**AMENDMENTS TO THE DRAWINGS**

**REMARKS**

Application No.: 09/885,688

FIG. 12  
PRIOR ART

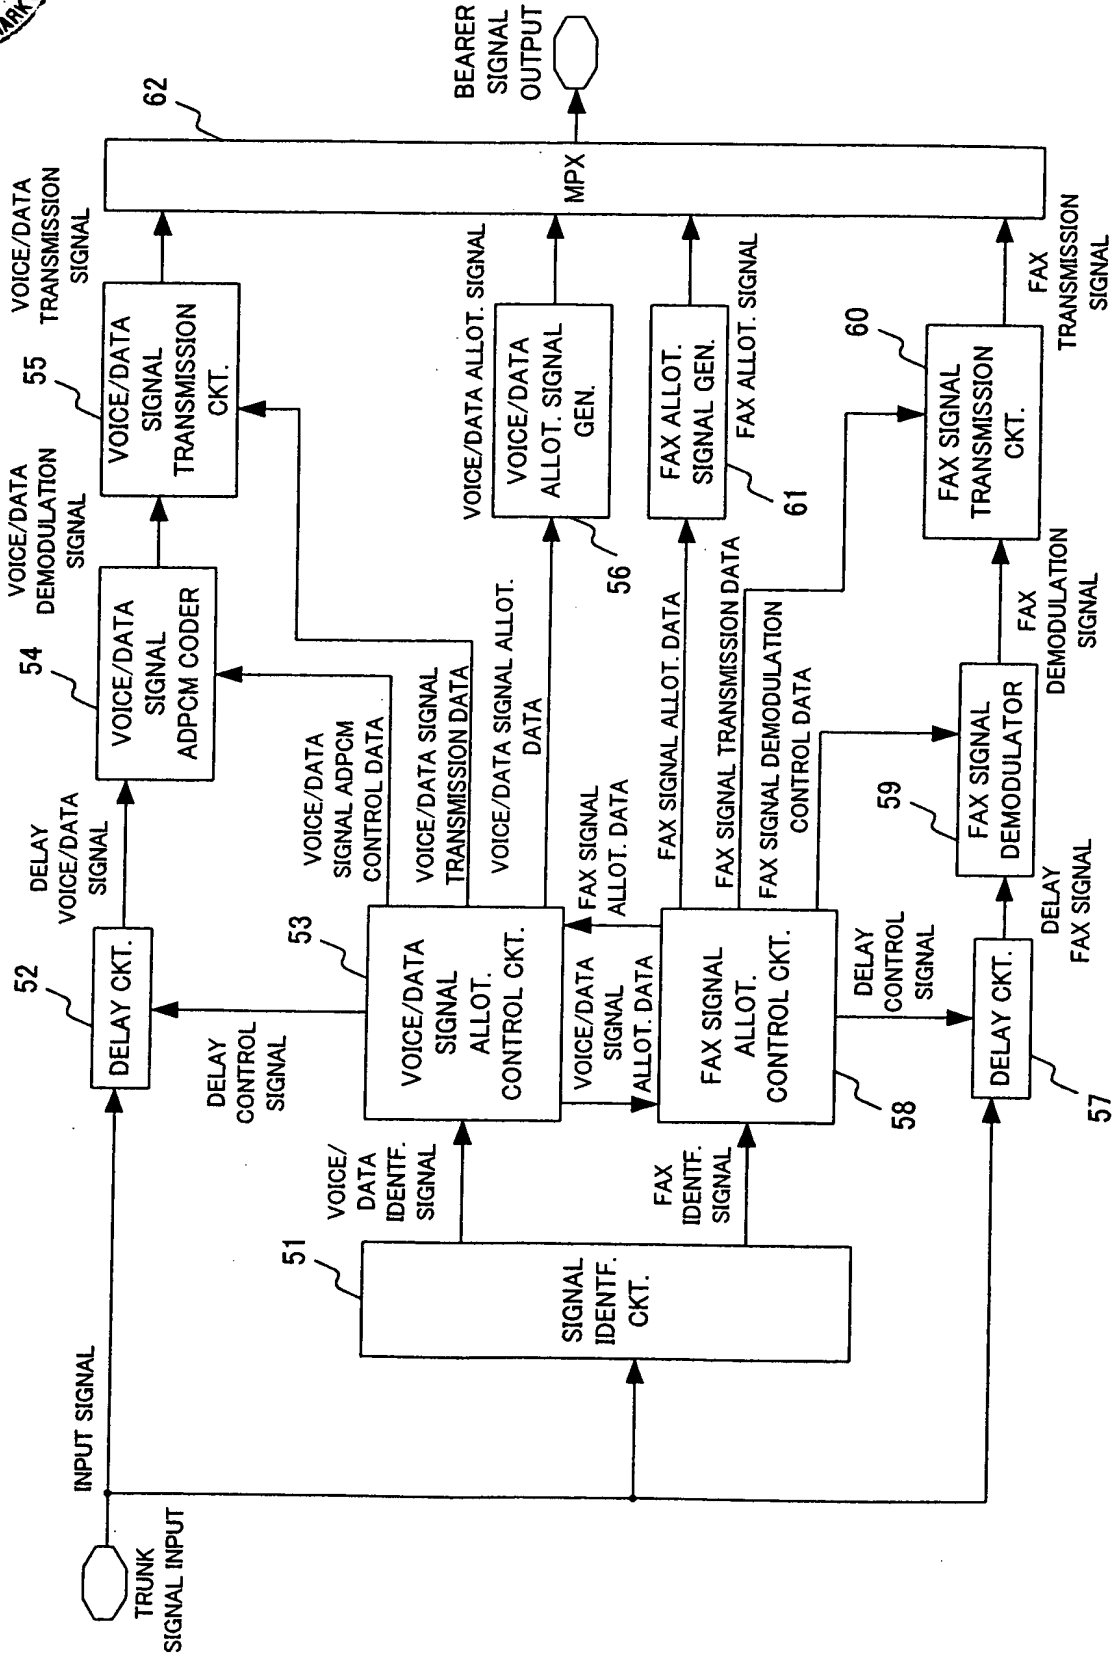
Figures 11 and 12 have been objected to under 37 C.F.R. § 1.121(d) for not being designated by a legend --Prior Art-- . Figure 12 has been objected to under 37 C.F.R. § 1.84(p)(5) because it includes a reference character not mentioned in the description. Claims 1-12 are pending and have been examined in the present application. Claims 1-12 have been rejected under 35 U.S.C. § 103(a) over the admitted prior art. Reconsideration of the present application is respectfully requested in light of the below remarks.

The attached sheets of drawings include changes to Figures 11 and 12 which have been amended to add the designation “Prior Art” in accordance with 37 C.F.R. § 1.121(d). Figure 12 has further been amended to correct typographical errors contained therein.

Figures 11 and 12 have been corrected to include the designation “Prior Art.” Figure 12 has been amended to exclude the “FAX control signal” reference. The inclusion of this reference character in Figure 12 was due to a typographical error. Its exclusion does not add new matter to the application. Withdrawal of the objection is therefore respectfully requested.
